**75.370**  
**Ventilation Plan**

Mine Safety and Health Administration  
604 Cheat Road  
Morgantown, West Virginia 26508

The request filed November 30, 2005, to maintain three open crosscuts at the Sago Mine, I.D. No. 46-08791, has been reviewed. The response to providing justification of merely increasing the air quantity 4,500 cfm above the minimum requirements is not adequate justification that ensures the safety of the miners. The request may be considered if sufficient justification is presented, other than for convenience, such as specific conditions on the working section that prevent the stoppings from being maintained to and including the third connecting crosscut outby the faces. Therefore, your request is not being approved.

PROPOSED SEALS

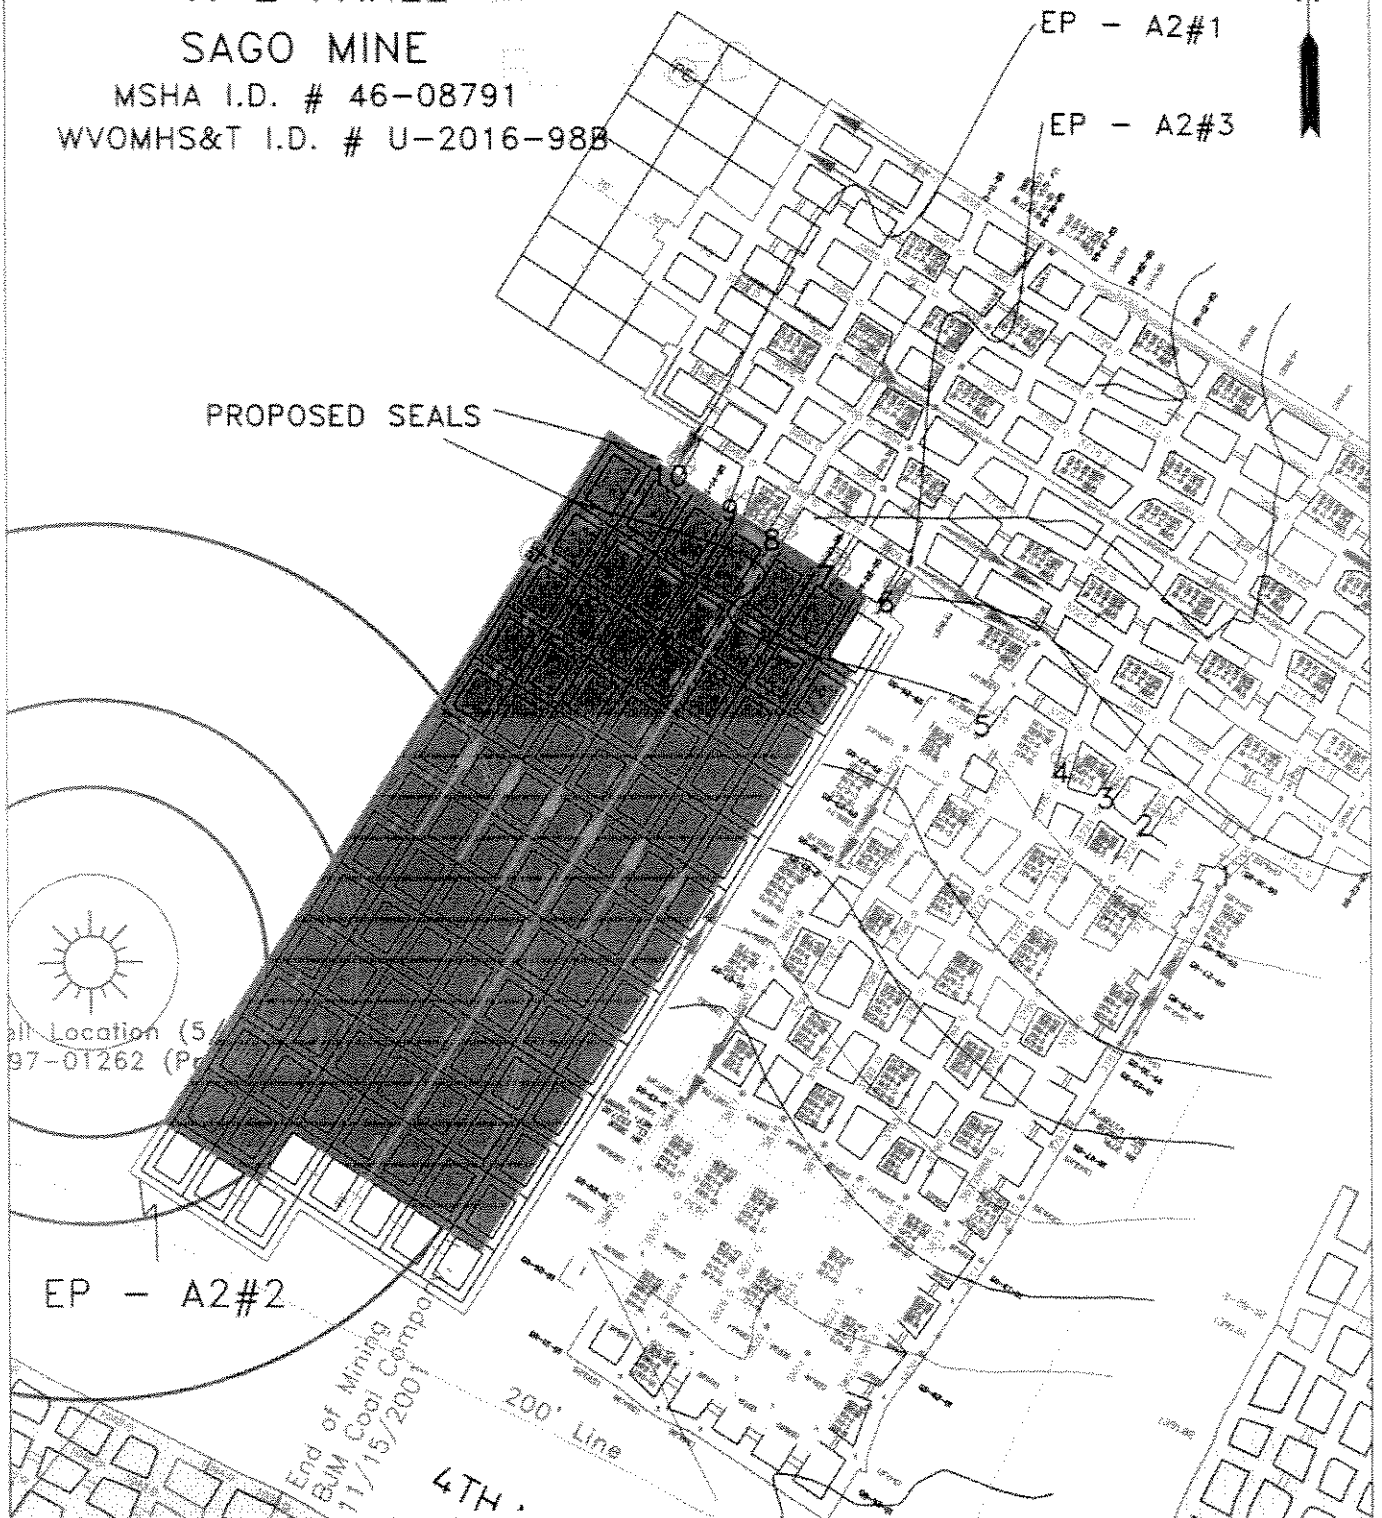
The following correspondence is concerning the second mining of our Sago Mine, (MSHA I. D. No. 46-08791 & State I. D. No. U-2016-98B). We wish to respectfully submit an amendment to our current approved ventilation and roof control plans for the A2-Panel area of the Sago Mine for second mining of the lower bench of the Middle Kittanning Seam for both the entries and cross-cuts alike. Refer to attachment labeled (Projected Area) which shows proposed ventilation circuits and evaluation points and future seal locations once the panel is abandoned. Note: In the set of seals labeled 1 through 5, seals 1 and 5 will be built last, and in the set of seals labeled 6 through 10, seals 6 and 10 will be built last. For your information I have attached a detailed cut sequence map that will eliminate exposure of persons to heightened areas. A list of the safety precautions that have been successfully utilized in previously mined areas has been included that will be in effect during this application.

The request filed December 1, 2005, for a test area as shown in red on the accompanying map for the ventilation, evaluation to mine the lower bench of the Middle Kittanning seam and future seal locations of the A-2 Panel at the Sago Mine, I.D. No. 46-08791, has been reviewed and is approved. This information will be included in your currently approved mine ventilation plan.

### PROPOSED PLAN FOR CONSTRUCTION OF NON-HITCHED OMEGA BLOCK SEALS

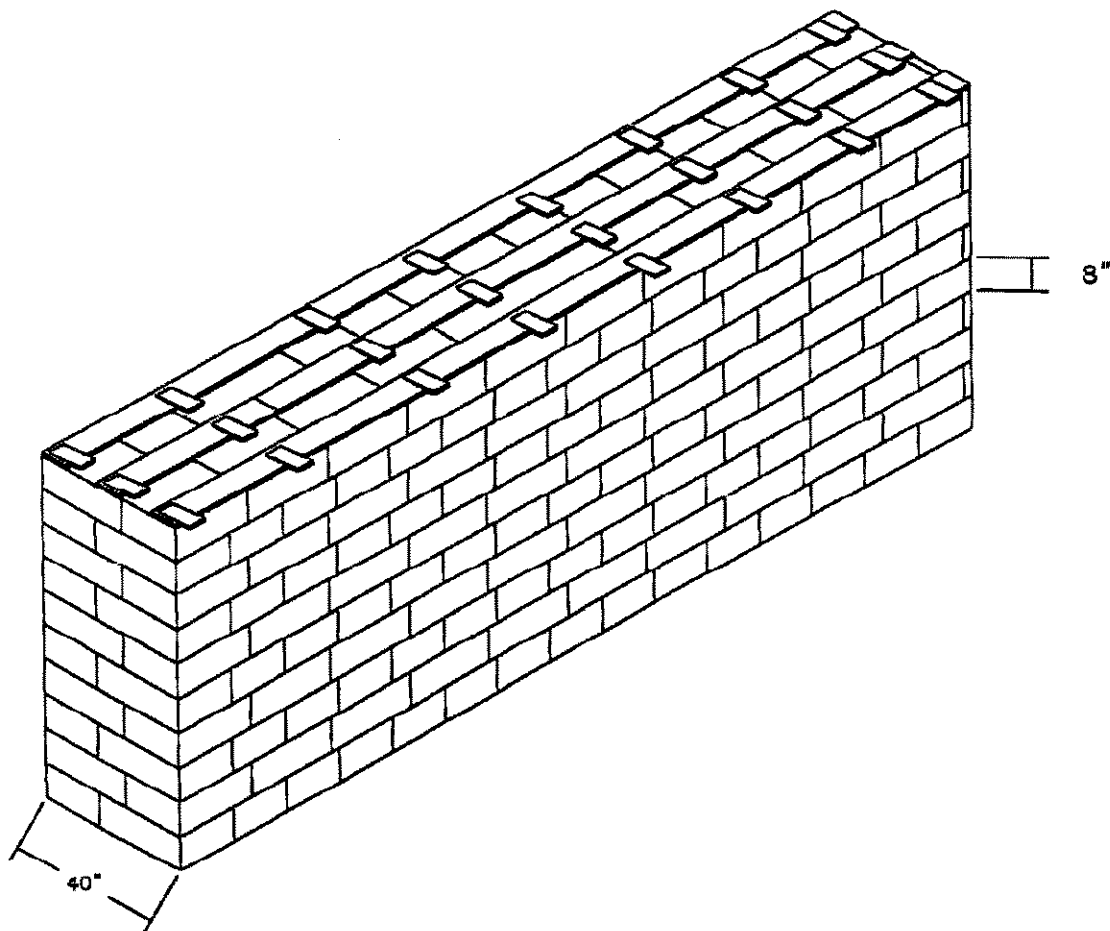
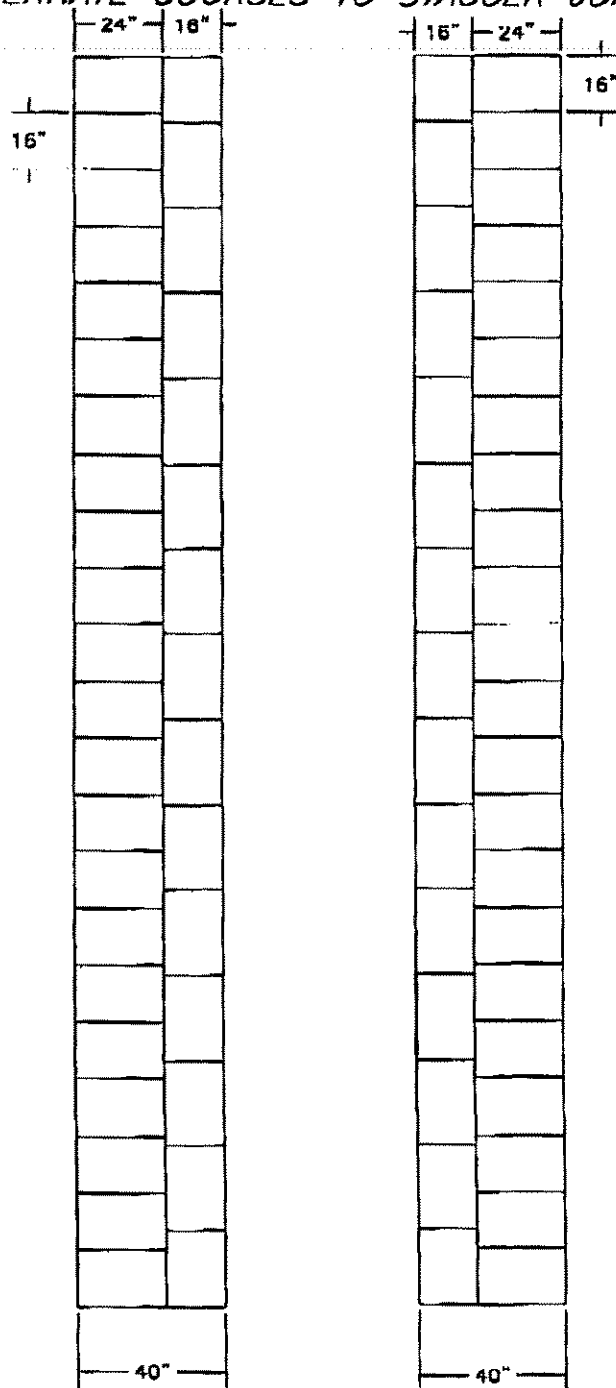
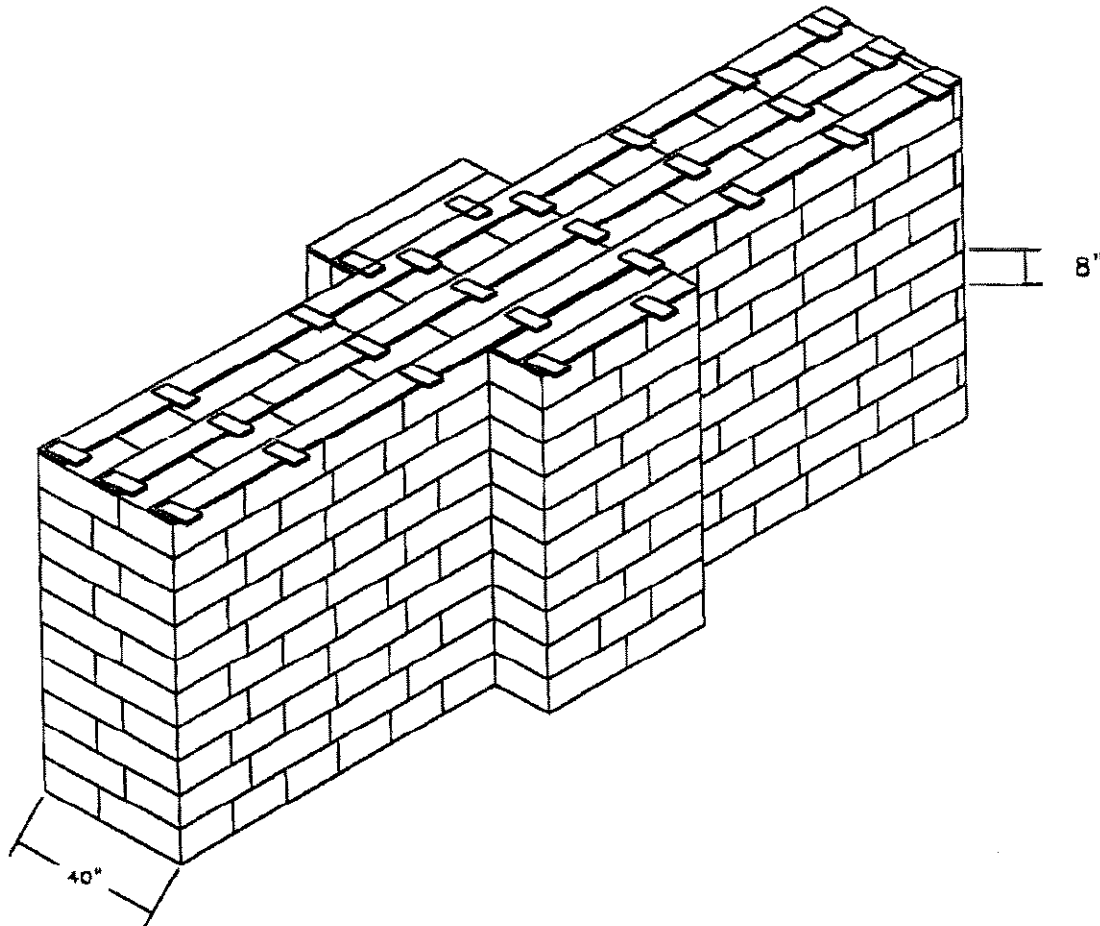
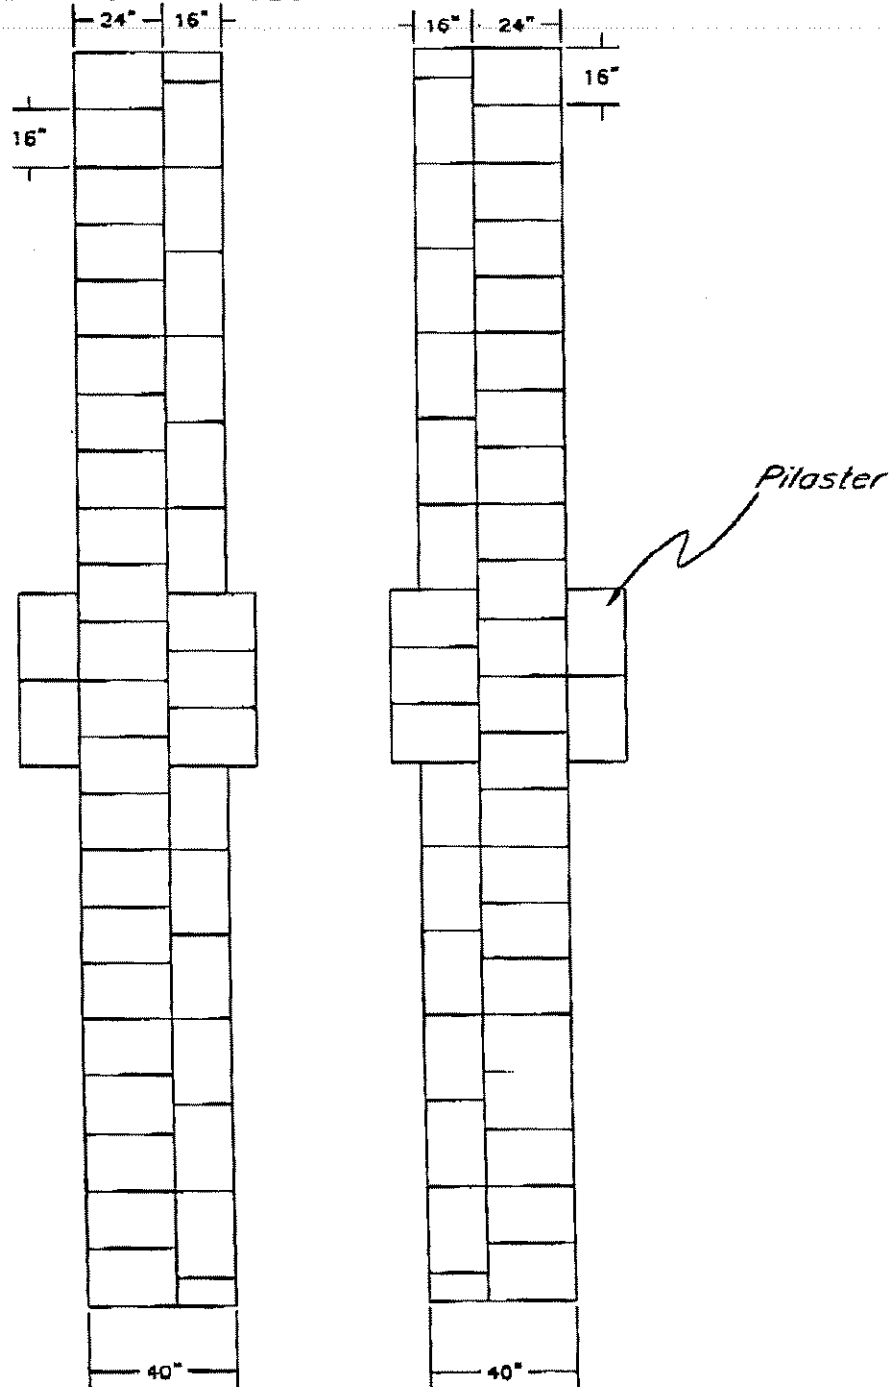
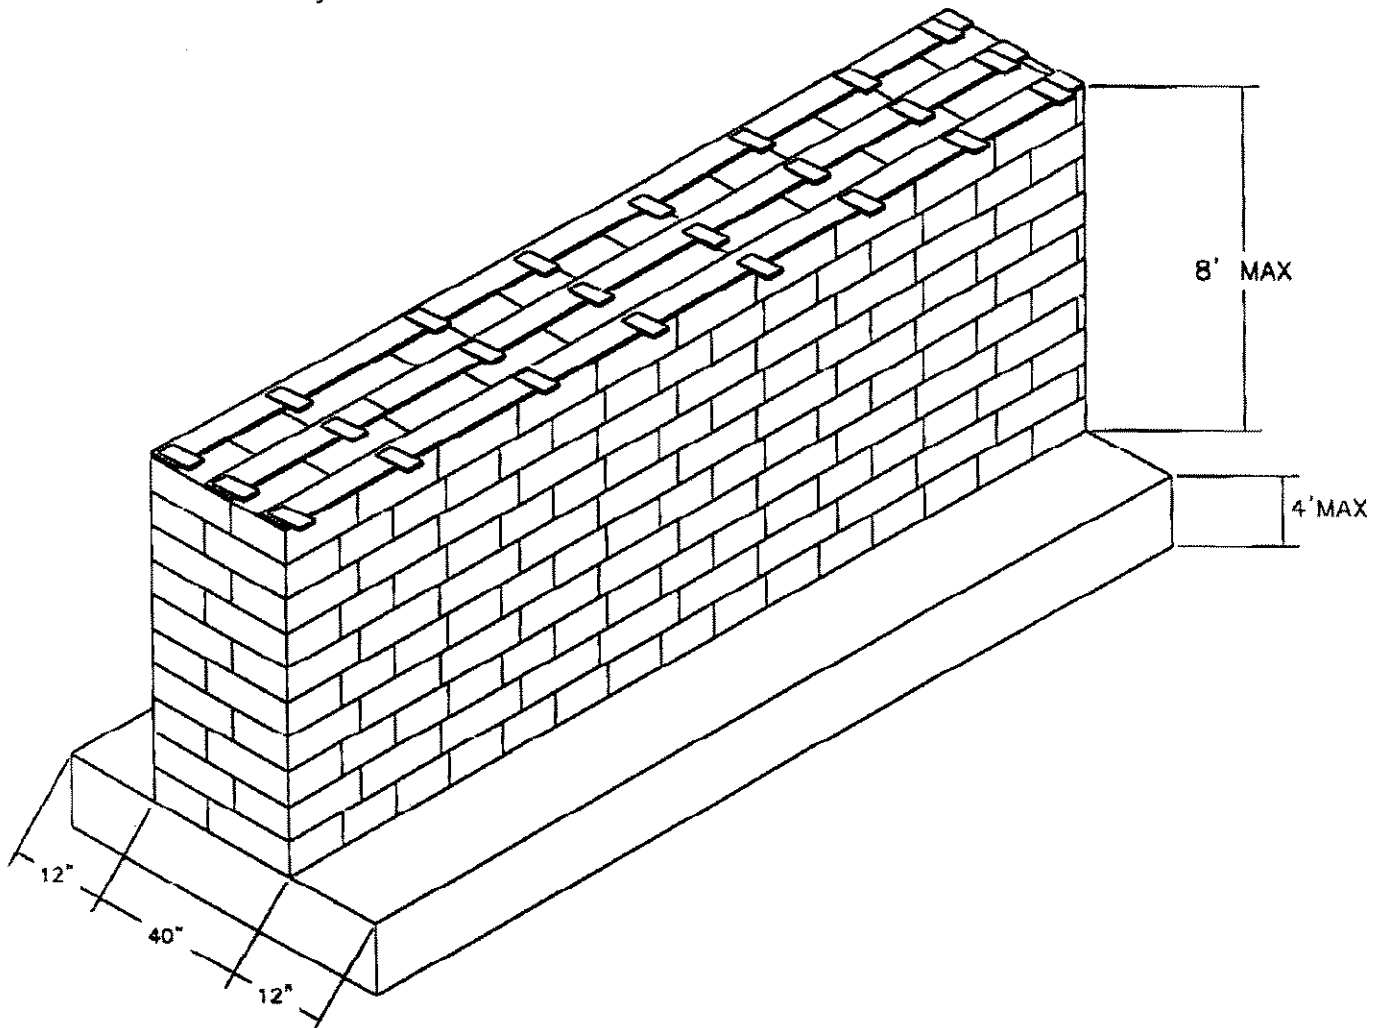
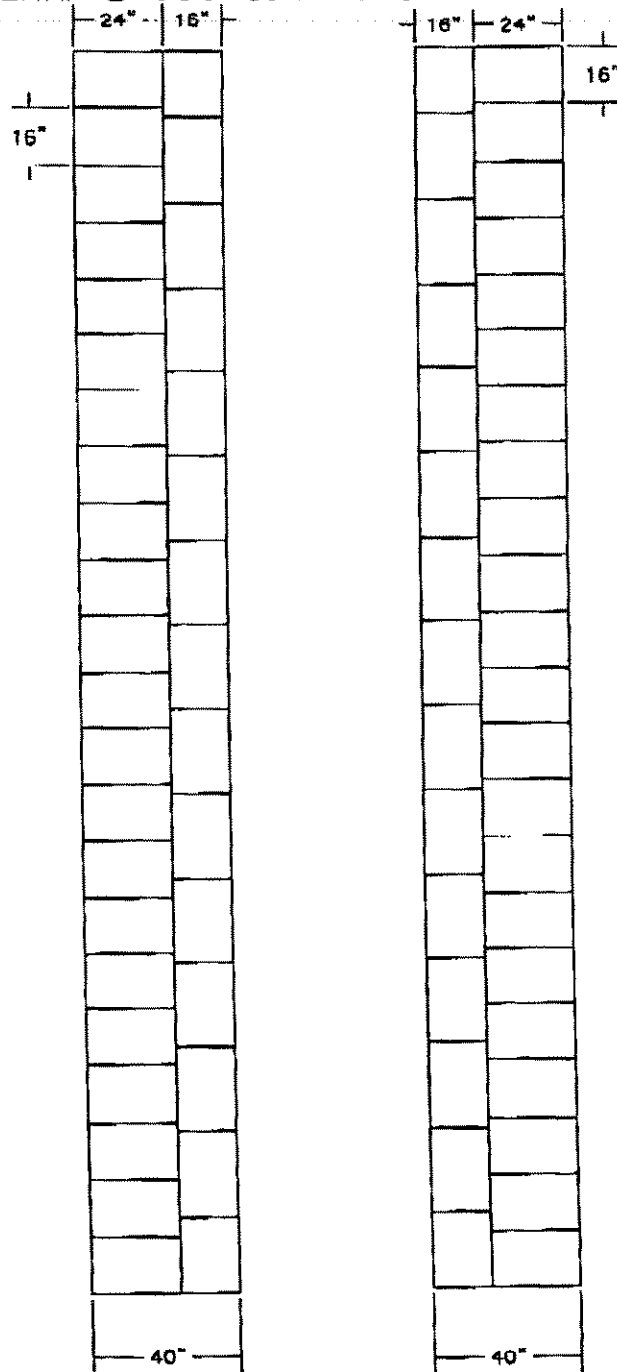
Anker West Virginia Mining Company wishes to submit an amendment to the proposed mine seal plan that was submitted to your office on 09-29-05 for the Sago Mine, MSHA ID # 46-08791. This proposal will address the addition of utilizing pilasters with the Omega Mine Seals when the mined height exceeds eight foot. Please refer to the attached technical drawing depicting construction and dimensions of this application. In closing if you have questions concerning this matter please feel free to contact me at 1-304-471-3300.

The request filed October 31, 2005, to add an alternative method of seal construction to the ventilation plan for the Sago Mine, I.D. No. 46-08791, has been reviewed. The alternative method seal with non-hitched style Omega blocks is approved and will be included in the currently approved mine ventilation plan.
